SERVICE BULLETIN

Subject: Sanction Standard Elite Float & Program Update Notification **Date:** 9/16/02

Distribution: All Sanction Standard Elite Customers **BulletinNo.** CEB02-11

CUT OUT THE FOLLOWING GRAPHIC AND PLACE ON KEYPAD

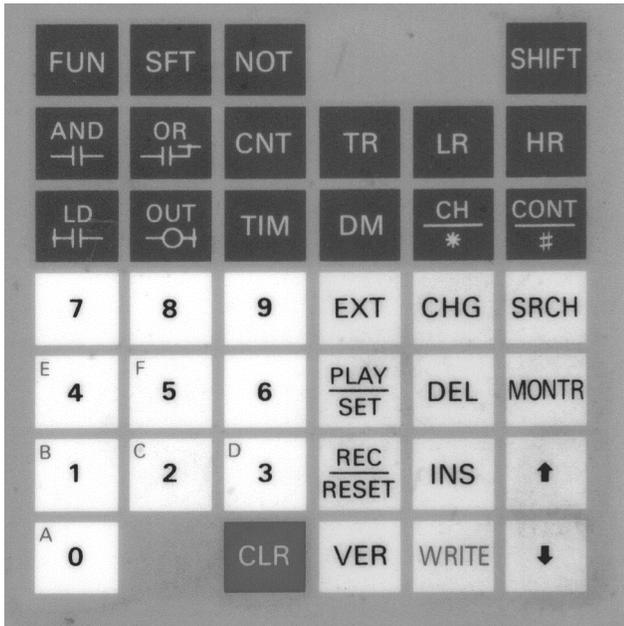
This procedure is designed to eliminate an Error Message that might occur due to an intermittent float switch signal coming from the float that is mounted in the roto-molded conditioner tank (This applies to machines with serial numbers: ELT-710 to ELT-784H). This float needs to be rotated and the way the PLC program handles the signal must be updated if this error is occurring even though the tank is full of conditioner. (There is a keypad overlay on page 2 that will have to be cut out and placed on the keypad to make these changes.)

LD
NOT
2
WRITE

AND
2
WRITE (The following will appear)
